# CITY OF ALBUQUERQUE

**Re: Apache Elementary – Kindergarden Addition, 12800 Copper Ave,  
Approval of Permanent Certificate of Occupancy (C.O.),  
Engineer's Stamp dated 12-01-08 (K-22/D003)  
Certification dated: 4-22-09**

**Re: Apache Elementary Kindergarten Addition Grading and Drainage Plan  
Engineer's Stamp dated 1-16-09 (K22/D003)**

**Re: Apache Elementary Kindergarten Addition Grading and Drainage Plan  
Engineer's Stamp dated 12-1-08 (K22/D003)**

**C-103**  
SHEET OF

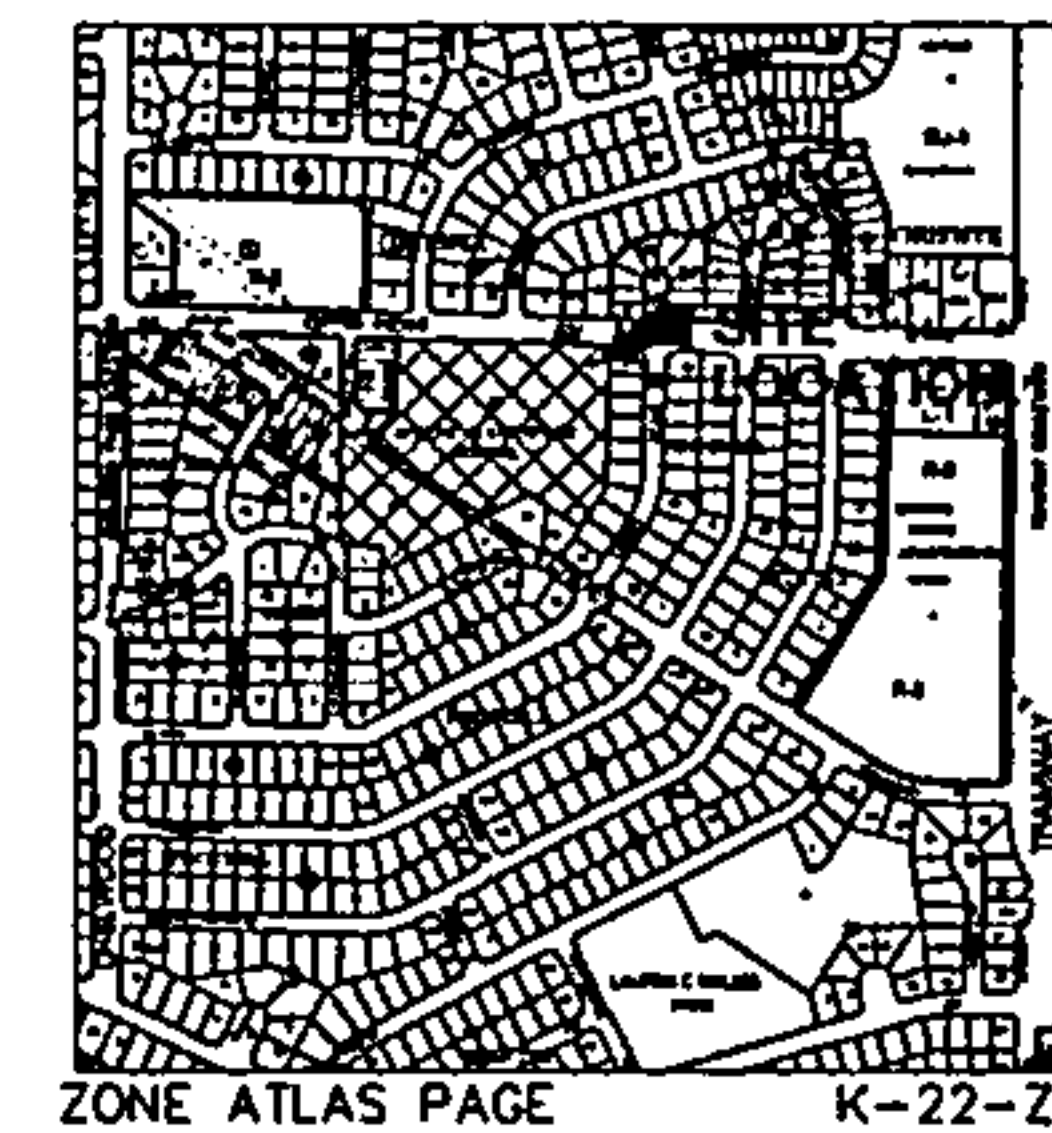
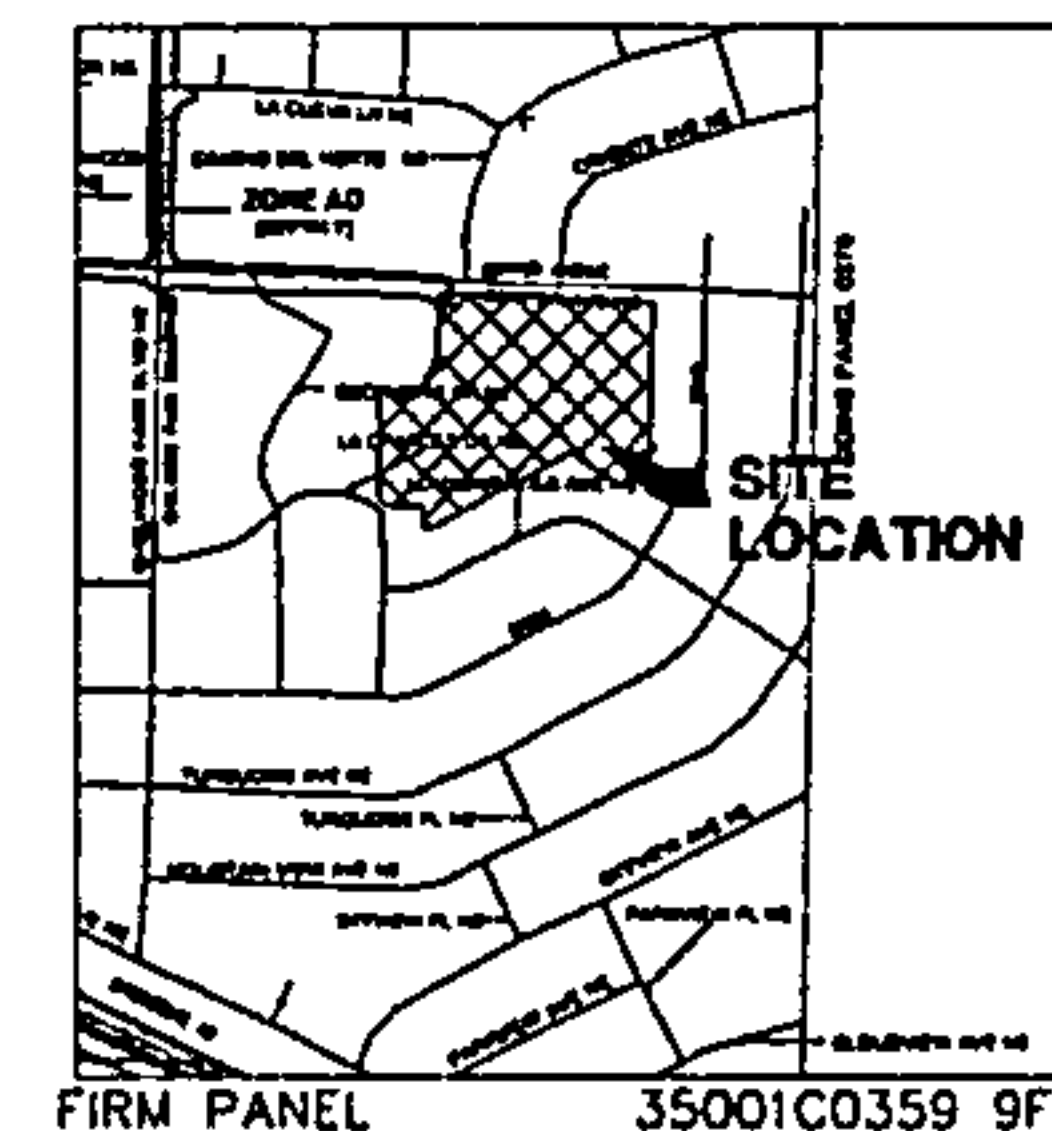
3. *Provide the Finished Floor elevations for the existing gym building east of the project area.*

**Please the attached sheet C-103 for the requested information.**

# POND GRADING PLAN

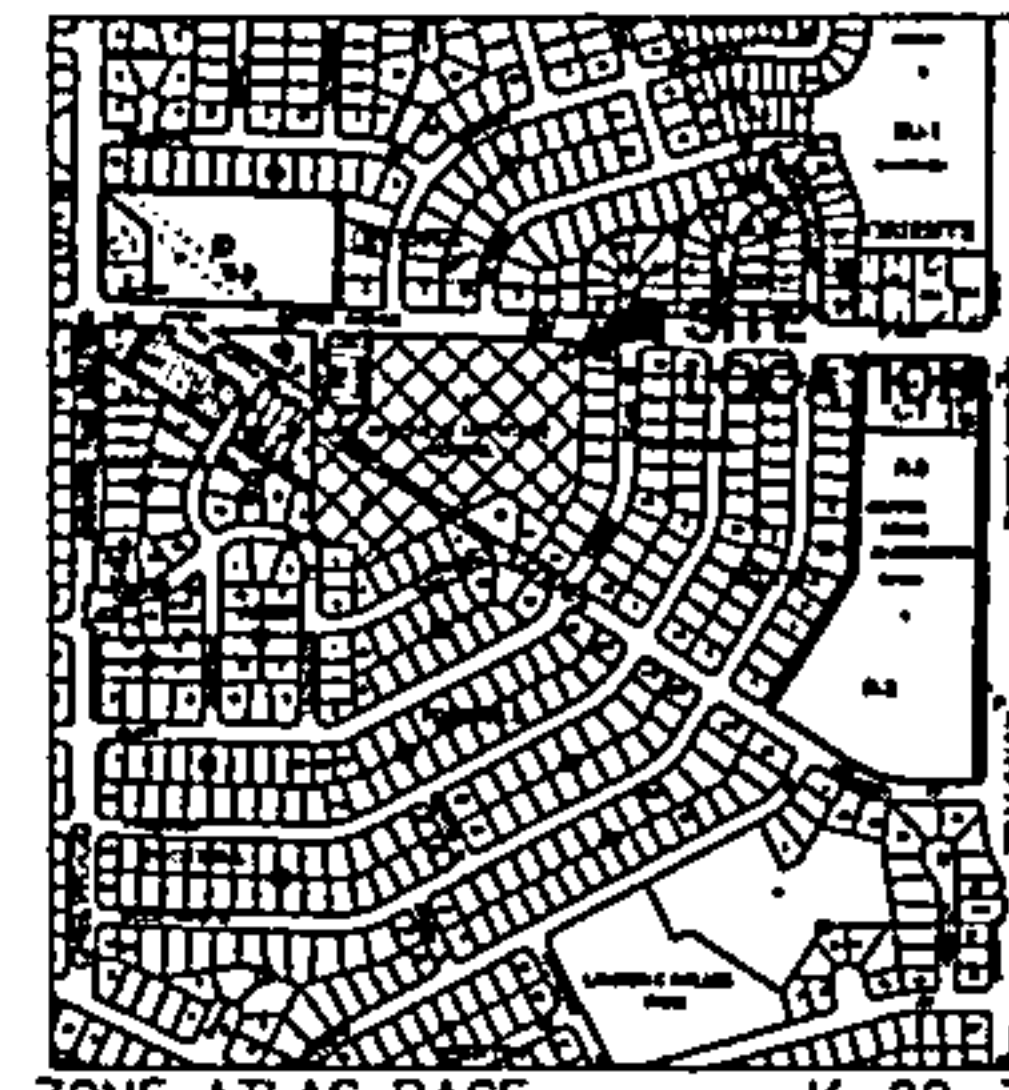
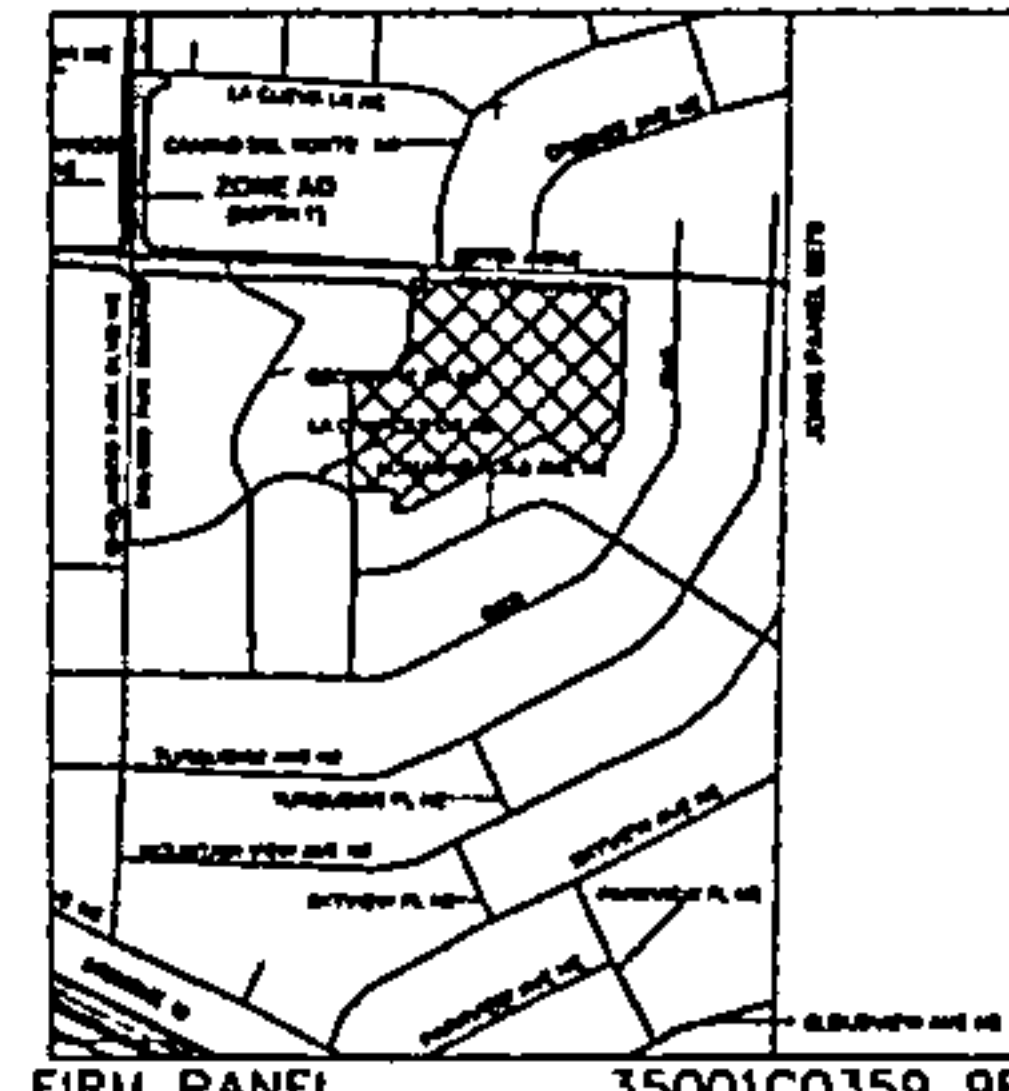
1. *Provide the volume required, volume provided and the water surface elevation for Pond 1 on Sheet C-104. Provide the top of the wall grade for Pond 1.*

**Please see the attached sheet C-104 with the revisions requested.**
